RE: Raintree POADP
Amendment dated July 2, 1986
File #83-20-63-44

PRELIMINARY OVERALL AREA DEVELOPMENT PLAN
for
RAINTREE SUBDIVISION
"A Morton Southwest Development"

RE: Raintree POADP
(File #83-20-63-44)
Reviewed November 25, 1985

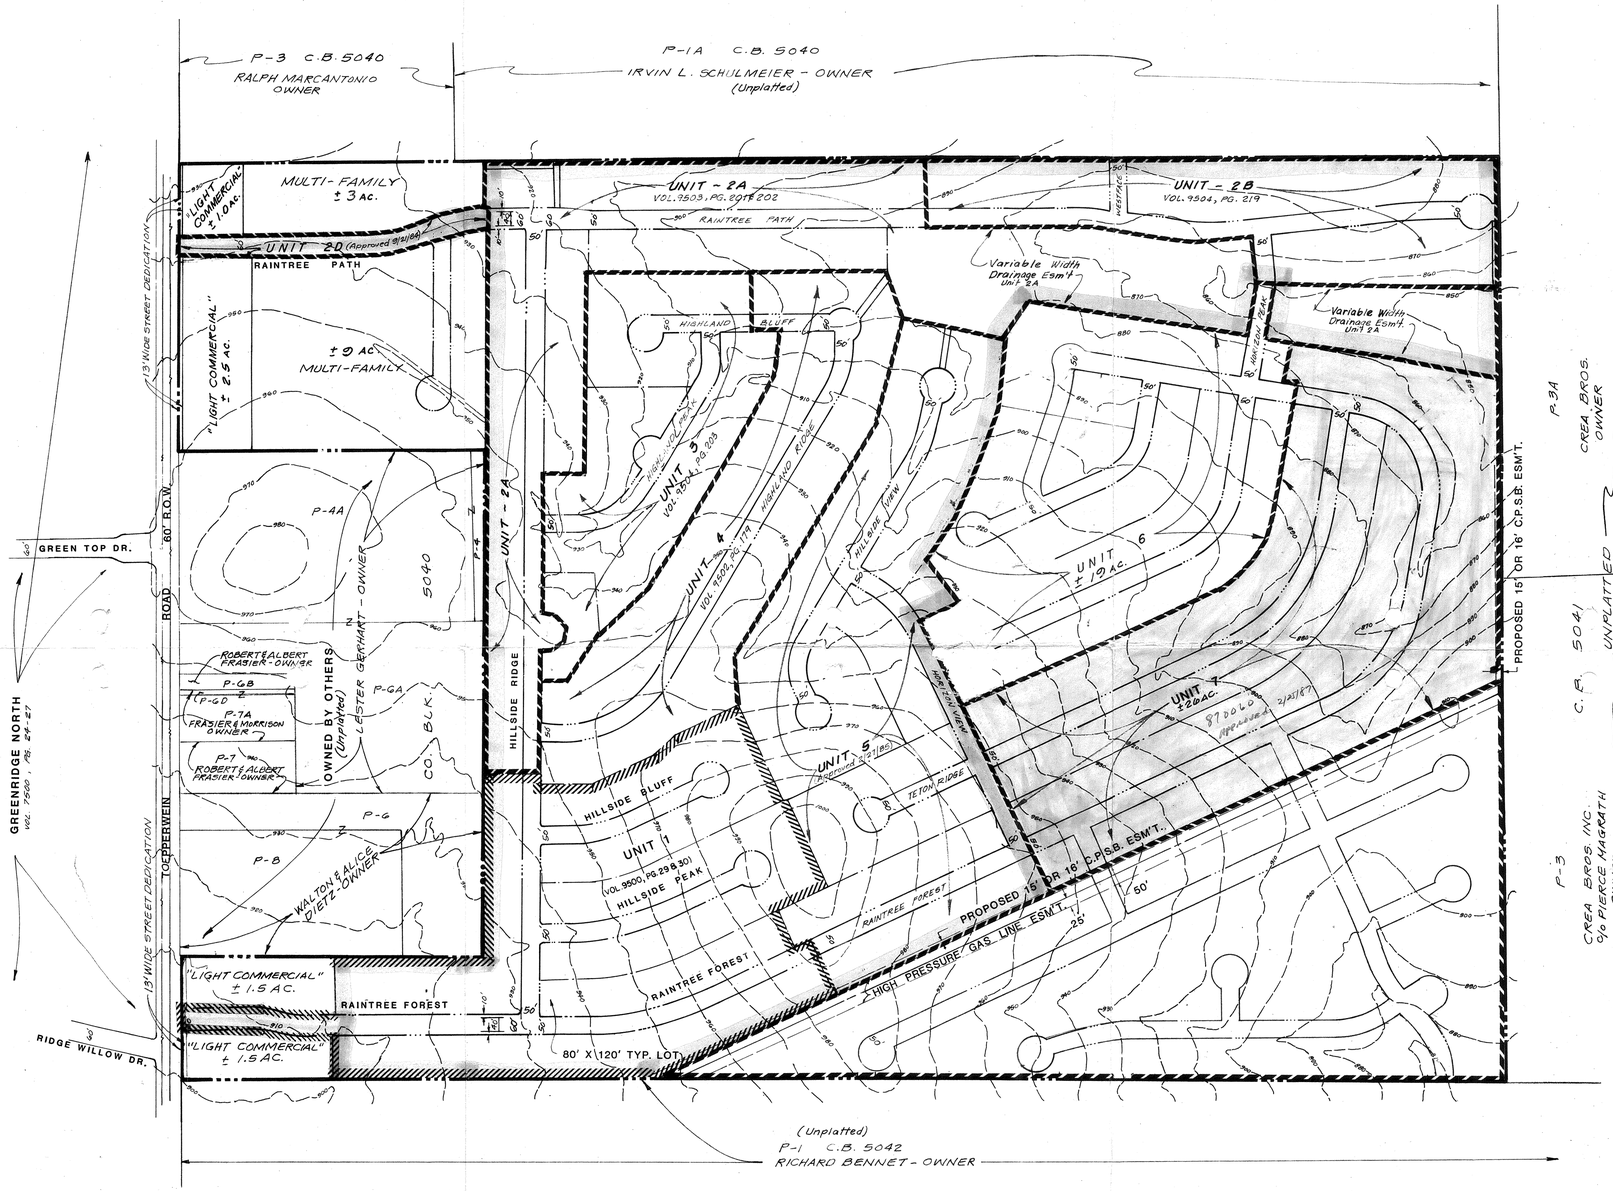
This is to inform you that the POADP committee has reviewed and accepted your plan of Raintree.

The POADP Committee reviewed the Raintree Plan and recommends that only one stub street be provided at point C on the attached sketch.

For your information, the staff policy is that stub streets should be collectors with a 60 foot right-of-way. In this instance we see no need for a 60 foot right-of-way as Raintree Forest is only 50' also. If this recommendation is unacceptable we are available to discuss other alternatives. Thank you for your cooperation in this matter and please call our office at 299-7900 if you have any questions.

The Committee expressed concern about what it considers to be an unnecessarily long cul-de-sac street in Unit-9 and recommends that a loop street be provided to lessen the cul-de-sac street length (see attached plan). The Committee also requests that the stub streets in Unit-9 be eliminated.

The above has been reviewed by the P.O.A.D.P. committee and has determined that it is in general compliance with the Subdivision Regulations. The revised plan reflects a new street design in Unit-6 which is acceptable to the committee. Overall, our comments regarding cul-de-sacs and Major Thoroughfares as noted to you on our memo dated April 11, 1983, are still valid.

( ) Street layout
( ) Relation to adjoining street system
( ) Stub streets
( ) Street jogs or intersections
( ) Dead-end streets
(X) Cul-de-sac streets in excess of 500'
( ) Low density lots fronting onto major thoroughfares
( ) 24' alley(s)
( ) _____

(X) Comments: It is noted that staff comments dated April 11, 1983 regarding cul-de-sacs and major thoroughfares still apply.

Our review concludes that the overall scheme is in general compliance with Chapter 36 of the City Code. However, it is recommended that the 60' R.O.W. (Raintree Path) at its entry point with Toepperwein Road should be continued to the eastern limits of the proposed development. This in our opinion would allow future extension and cause a viable east and west collector system which will carry traffic from adjoining areas, potentially between F.M. 1604 and Toepperwein Road. From the information made available to us from your office, it is our understanding that some preliminary work may be underway on Units 2A and 2B containing the street in question. We, therefore urge you to take this into consideration.

Another issue addressed in the review is the proposed cul-de-sac streets. Although some cul-de-sac streets exceed 500' as referred in Sec. 36-10(H) of the City Code, the street design work must take into account the expected density, land use, safety and convenience of the street network. Upon application of a letter of certification with the Department of Public Works for plats containing cul-de-sacs in excess of 500', then it will be necessary for your firm to address the facts in writing which warrant the design. Additionally, it is noted that Toepperwein Road is classified as a secondary arterial type "A" street (86' R.O.W.). Any platting taking place along this stretch of thoroughfare will require dedication for street widening as dictated by the Major Thoroughfare Plan.
